Re: Request for PAP Updates per USFS Request, Cyprus-Plateau Mining Company, Star Point Mine, ACT/007/006, Folder #2, Carbon County, Utah

Re: Response to September 22, 1987 Letter, Plateau Mining Company, Star Point Mine, ACT/007/006, Folder #2, Carbon County, Utah

Following are our comments on Plateau Mining Company's Five Year Permit Renewal Package:

Copied from Map 30

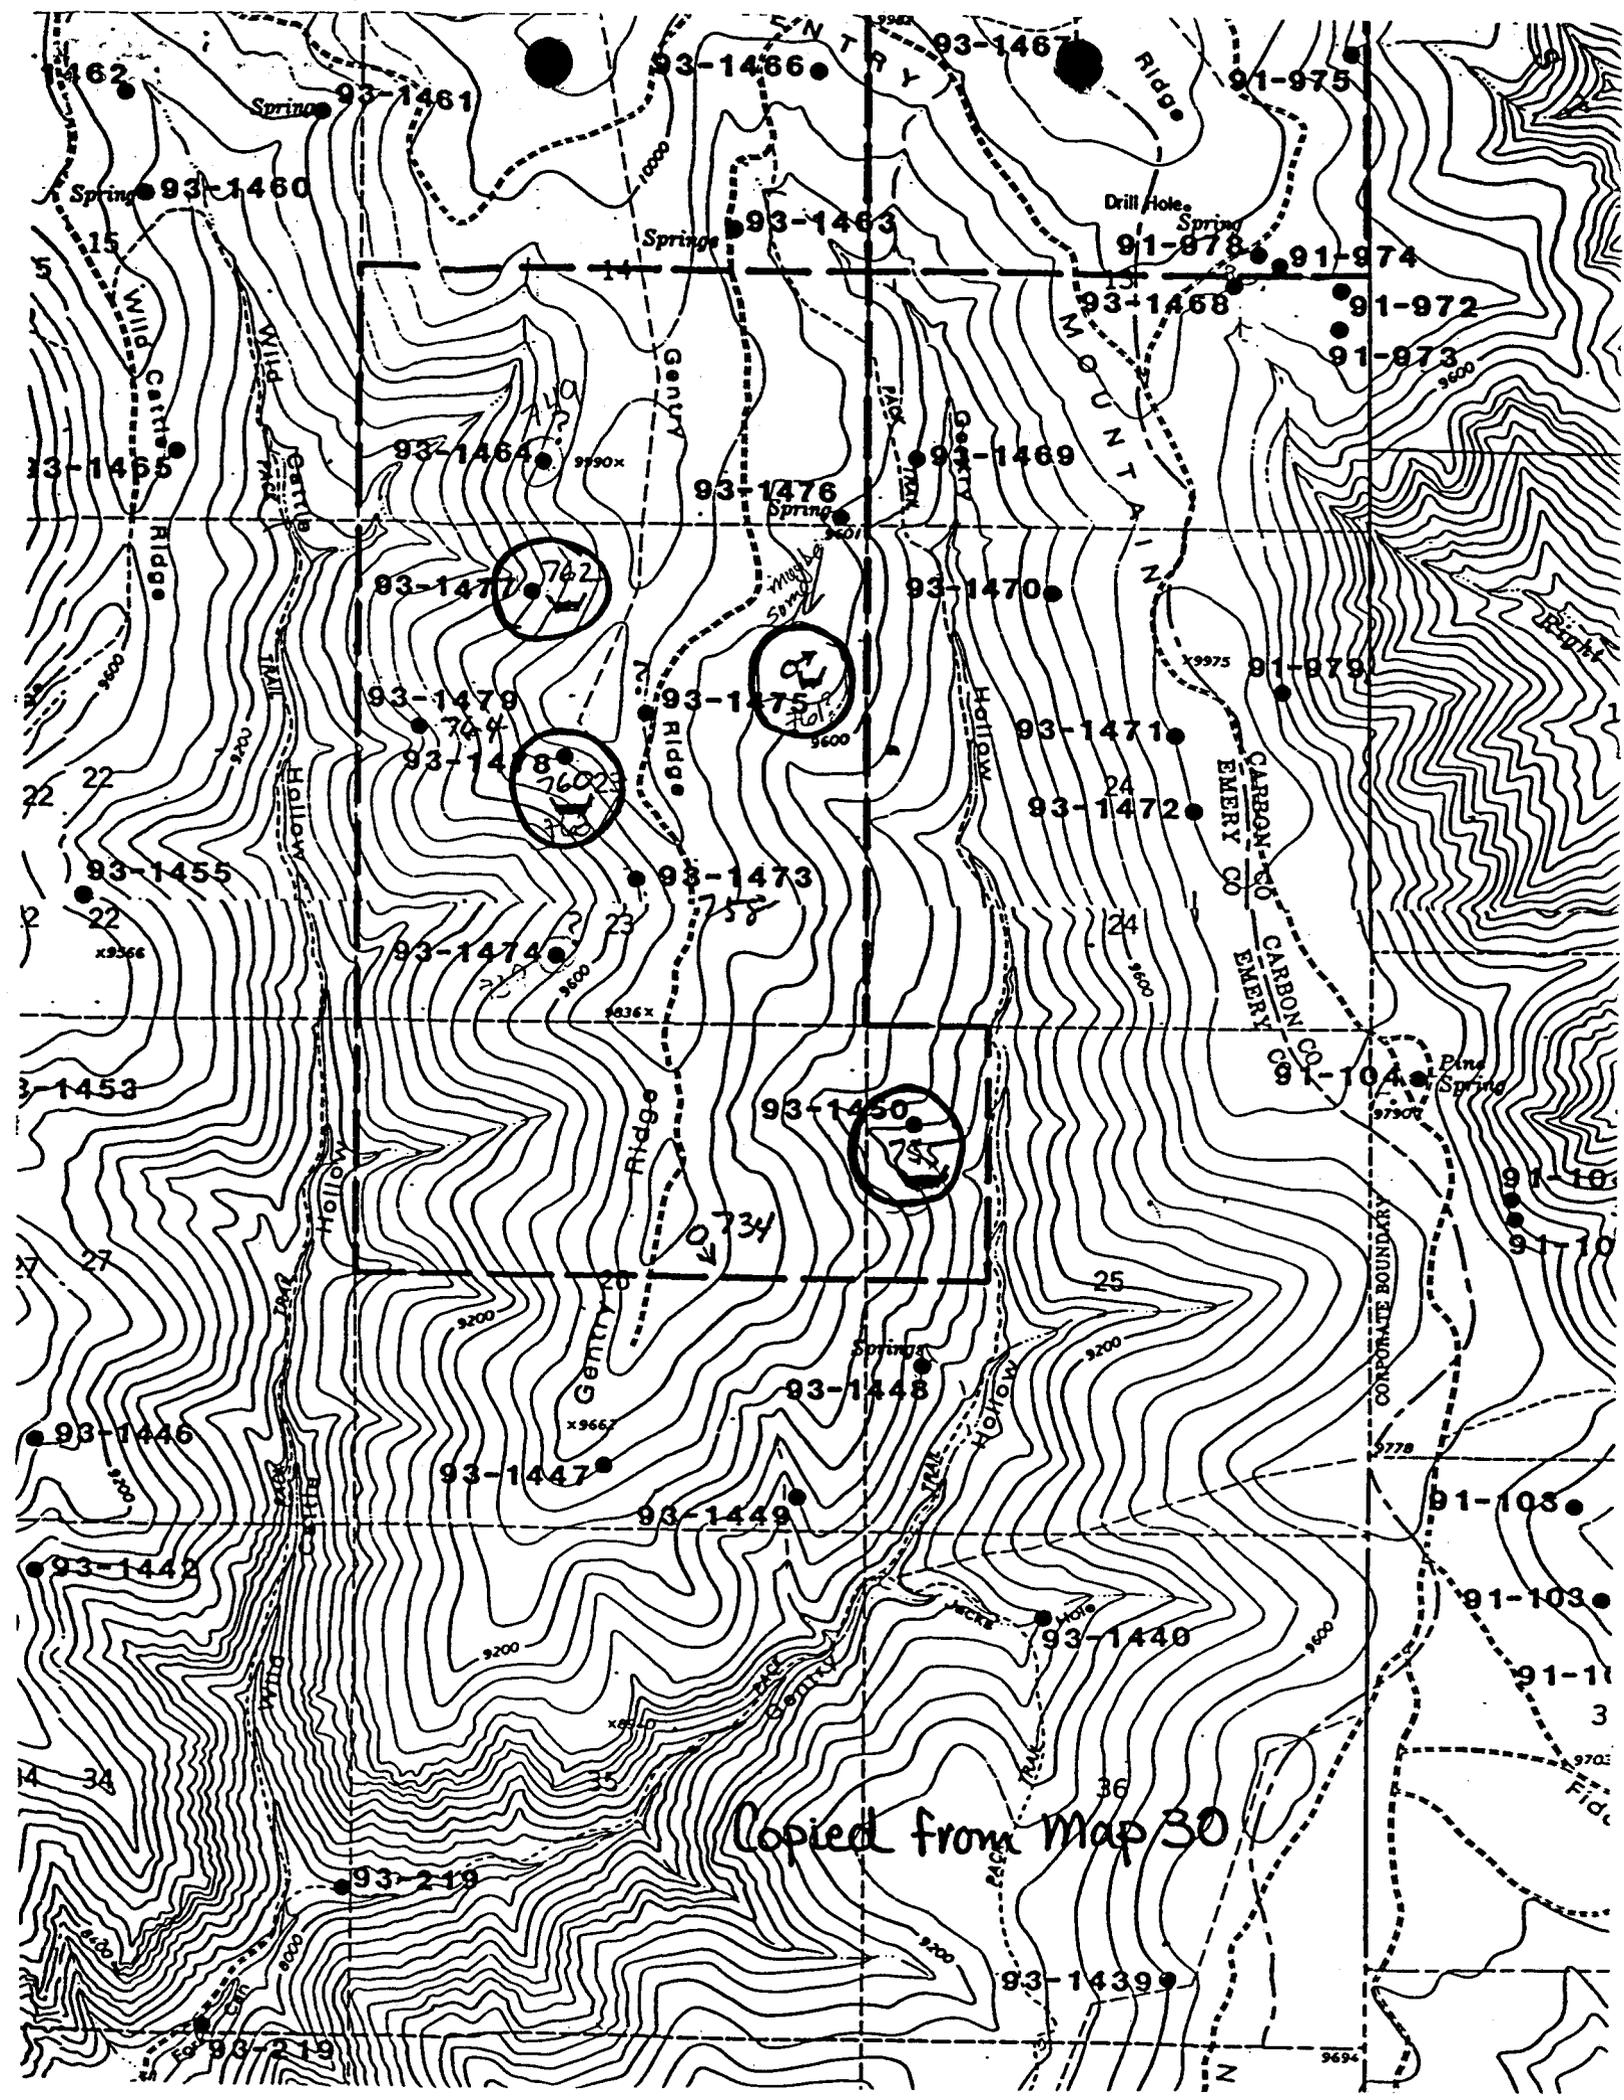
Map 31 shows that only spring 452 on Lease U-13097 will be monitored. Four springs within the lease have been developed by the Forest Service with troughs. They are circled on the enclosed map which was copied from Map 30. One of the springs was not identified by Plateau Mining Company. These springs must be monitored such that impacts from mining will be detected.
